March 4, 2002

**SUBJECT: Temporary Design Bulletin C02-03
Effective March 1, 2002**

FDOT NOISE WALL PILE/POST CONNECTION OPTIONS – GENERAL NOTES (Page 1 of 1)

**NOISE BARRIER WALL.
(REV 2-20-02)**

FDOT NOISE WALL PILE/POST CONNECTION - OPTION NO. 2A (Page 1 of 2)

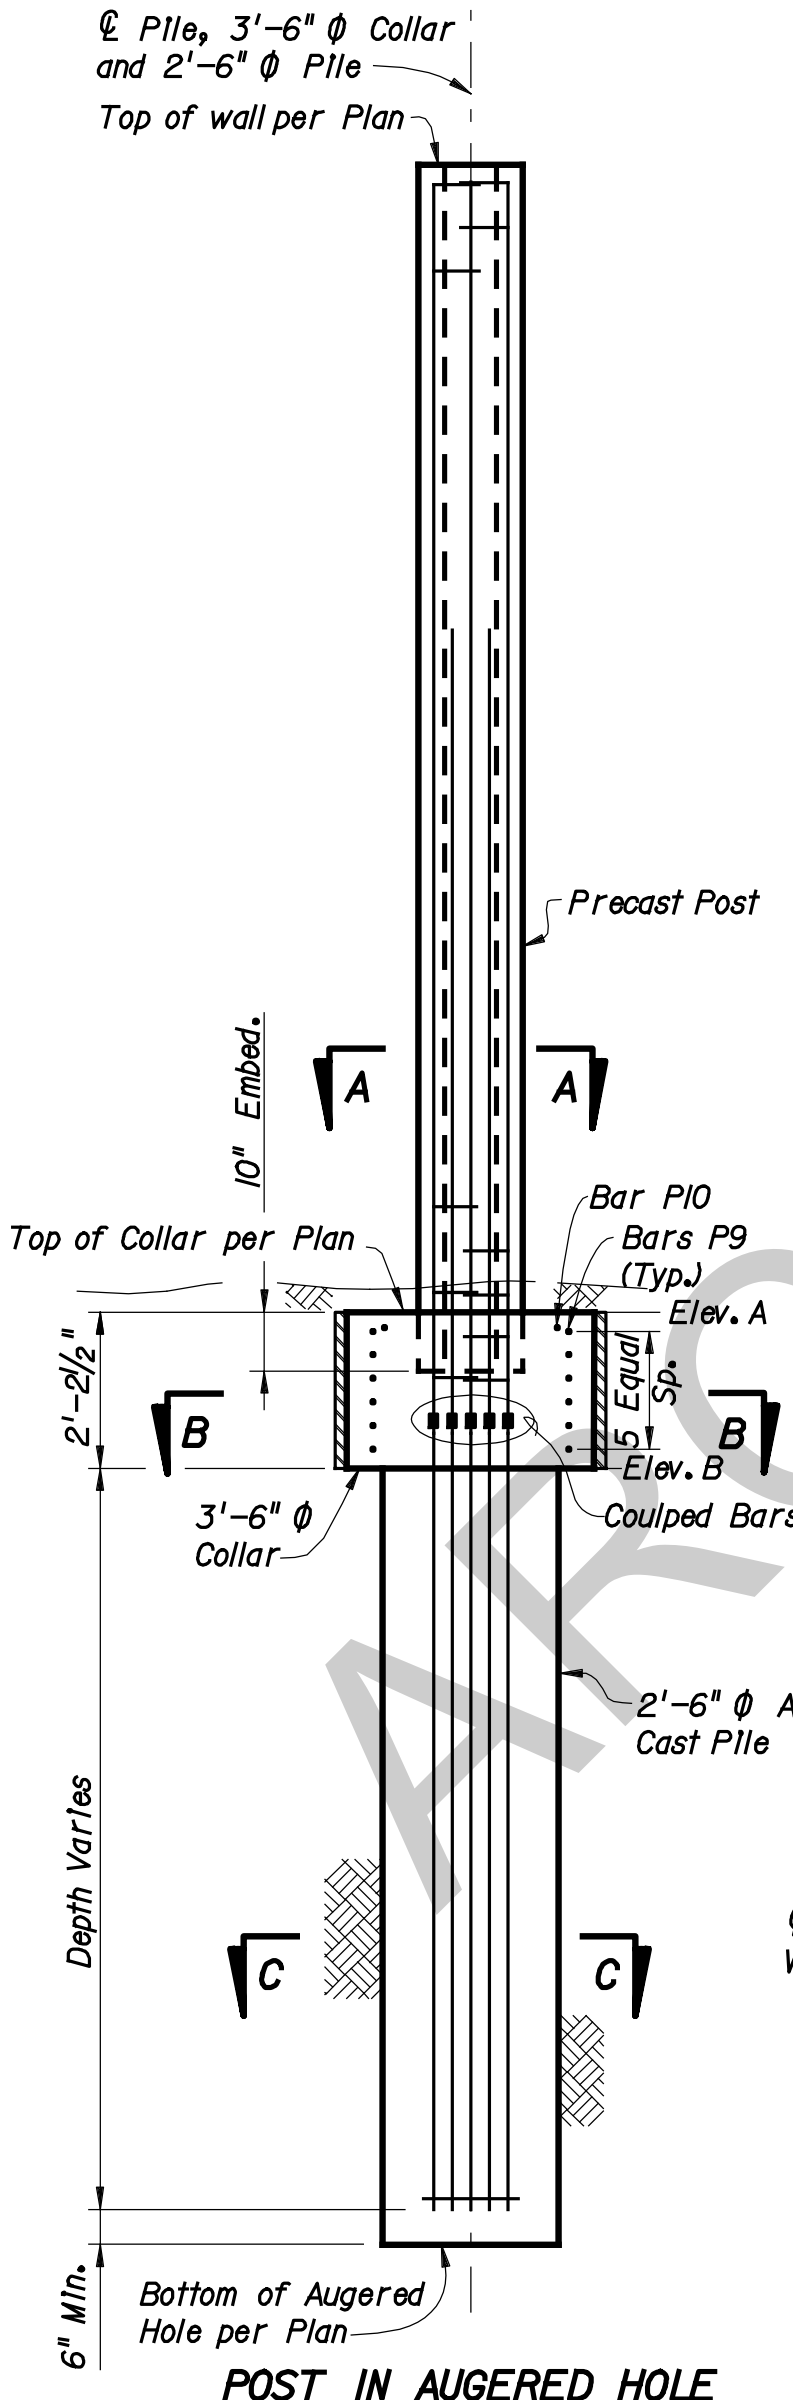
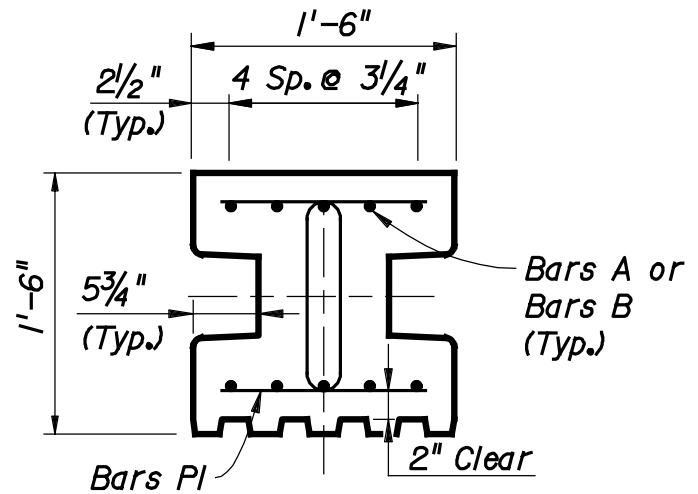
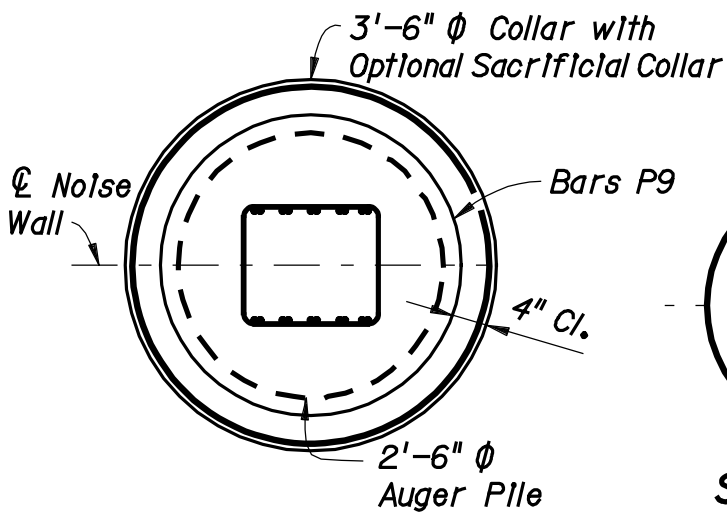
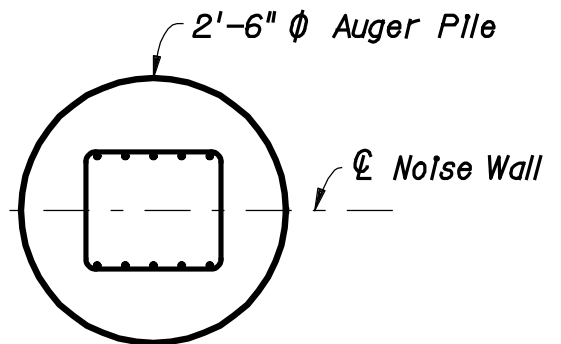
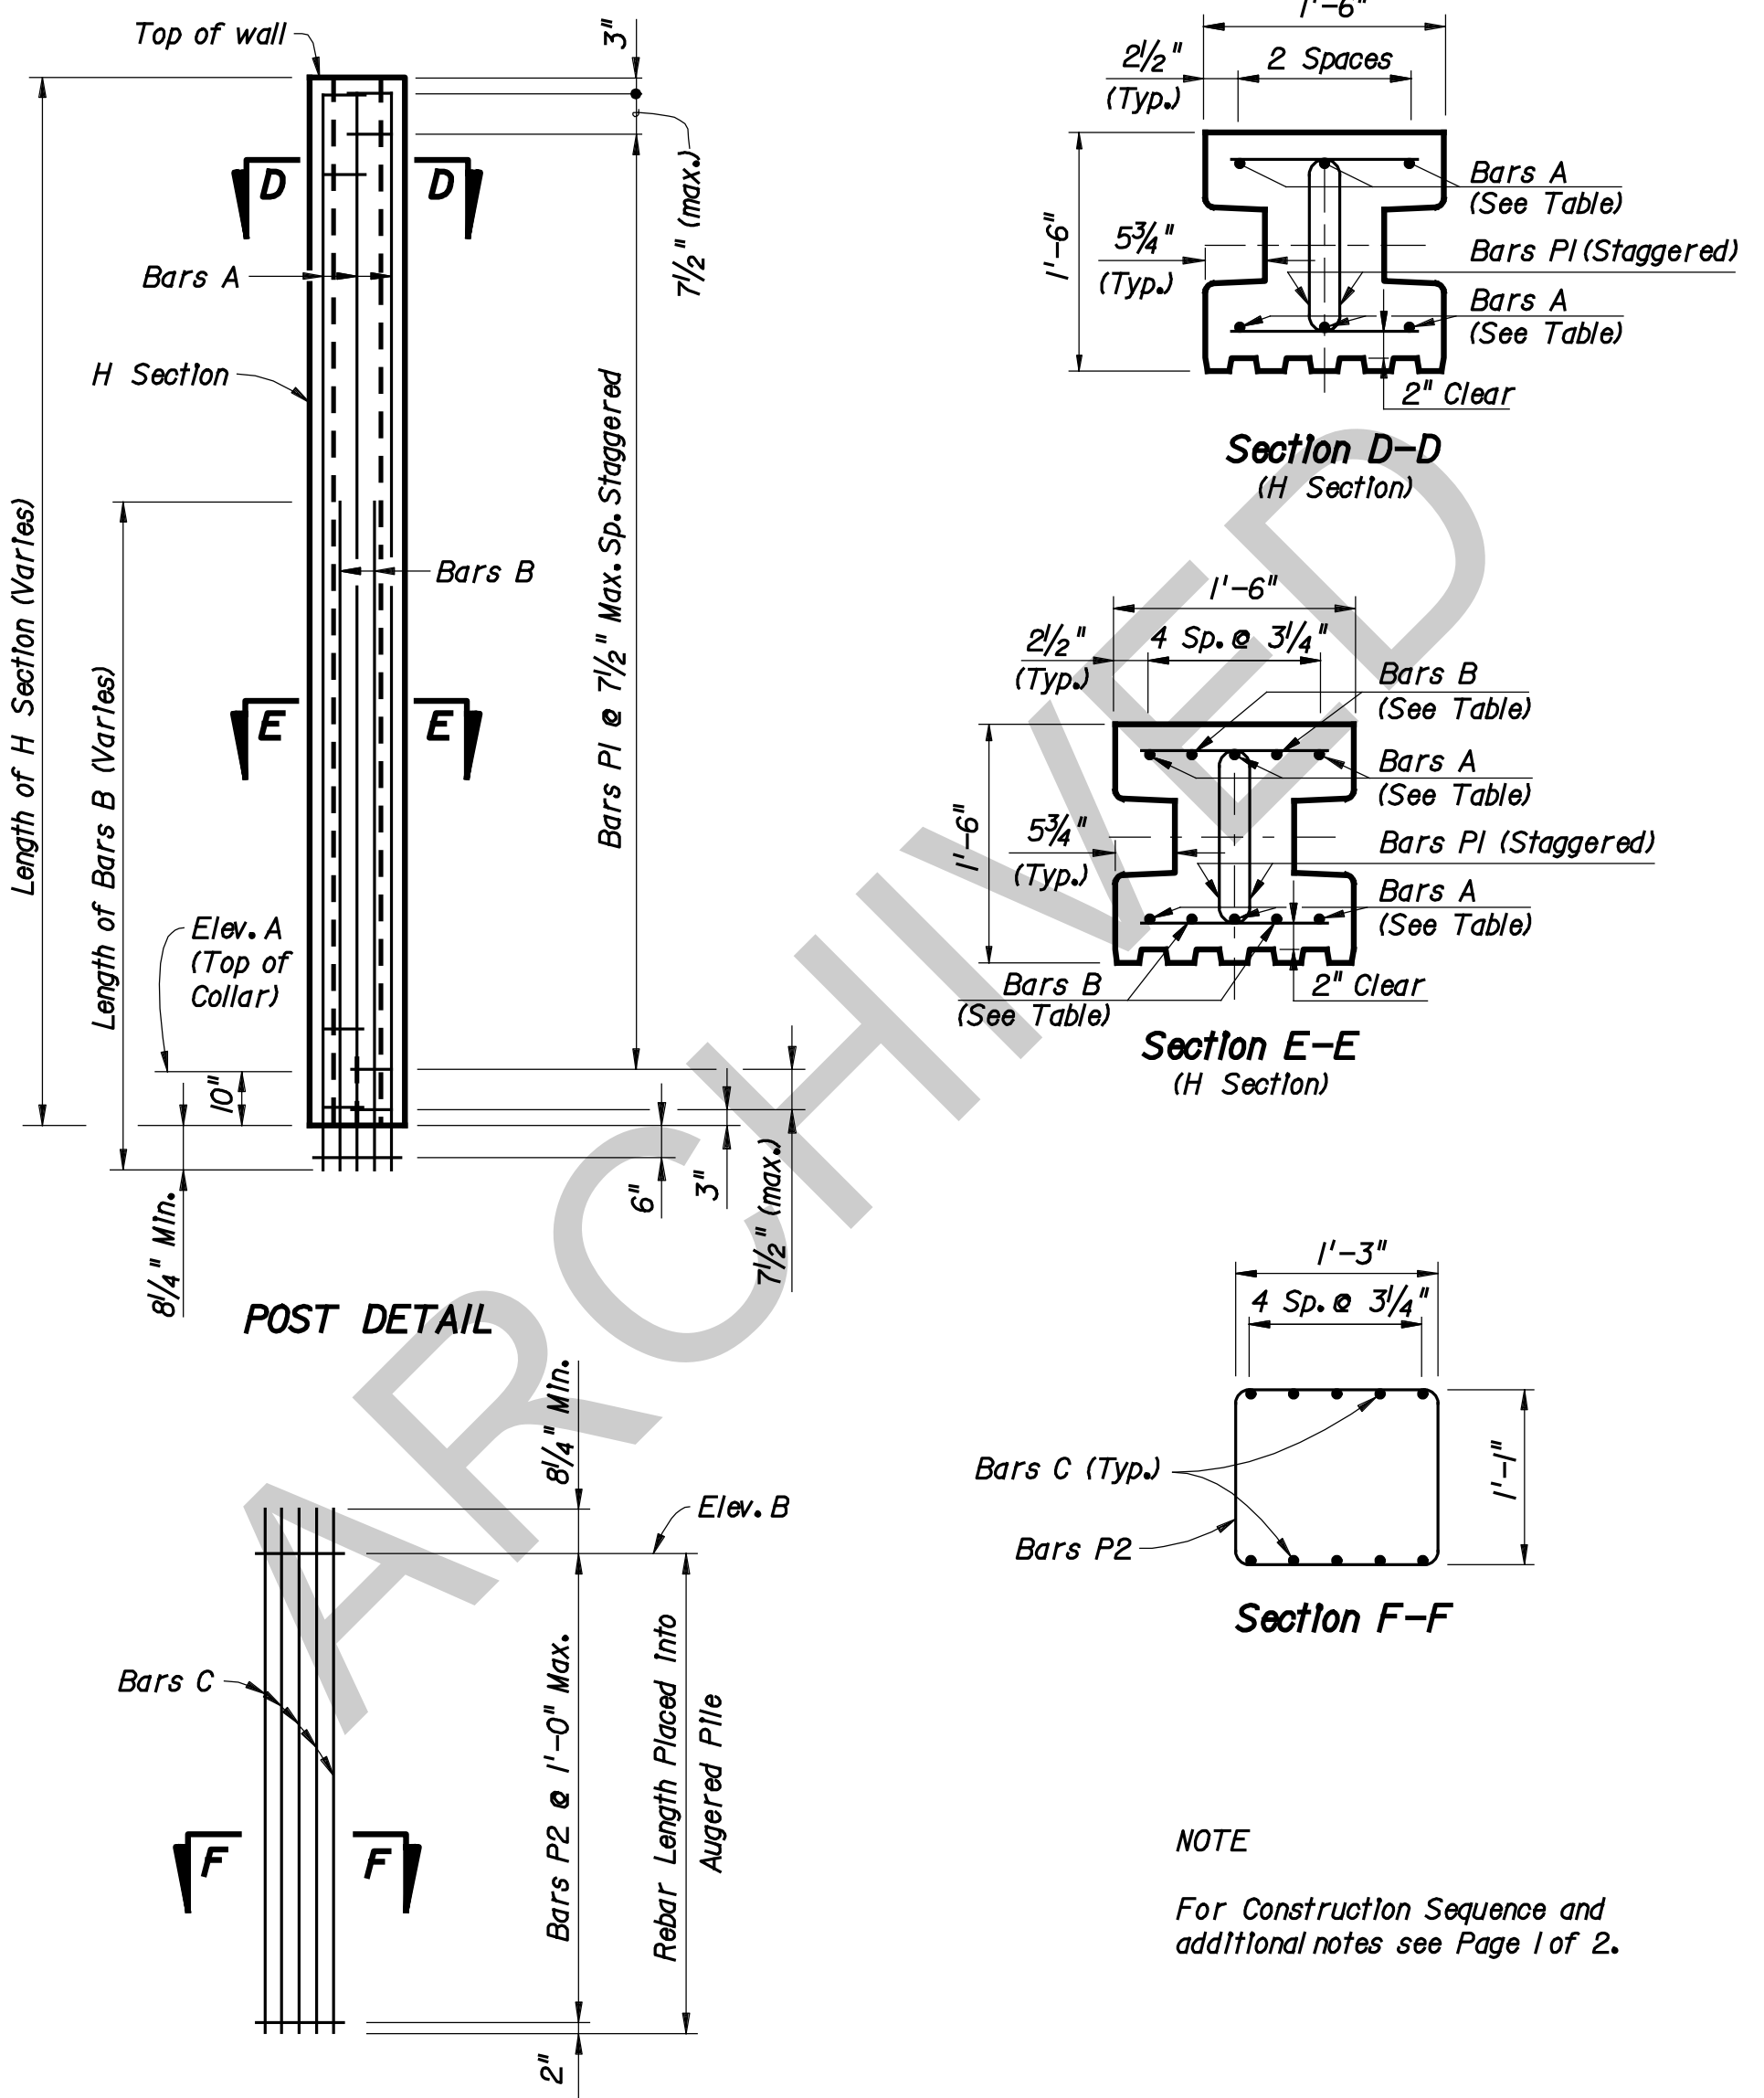
Requires cutting reinforcement Bars A and B in the post 8 $\frac{1}{4}$ " minimum below the bottom of post. The cut-offs of Bars A and B shall be used as Bars C to form a cage using the P2 tie bars. The bar cage shall be lowered into the auger cast pile and carefully positioned to allow for coupling Bars C with Bars A and B, at the base of the post, with mechanical couplers.

1. Cast the concrete H Post. See post detail on Page 2 of 2.
2. Temporarily excavate to Elev. B in the vicinity of the post.
3. Drill and cast a 2'-6" ϕ auger pile to Elev. B.
4. Place the rebar into the 2'-6" ϕ augered pile hole. See augered pile reinforcement Page 2 of 2.
5. Construct a template to properly align the precast post over the augered pile. Using mechanical couplers splice the precast post rebar with the rebar in the augered pile. The Contractor shall splice bars prior to placing pile reinforcement. Attachment and alignment may be made prior initial set of pile grout. The bottom of the H Post section (see section A-A) shall be 10" below Elev. A (Top of Collar).
6. Place the sacrificial casing or collar form and collar reinforcement.
7. Construct a 3'-6" ϕ collar to cover the mechanical splice. Cast the concrete collar and finish the concrete to Elev. A (Top of Collar).
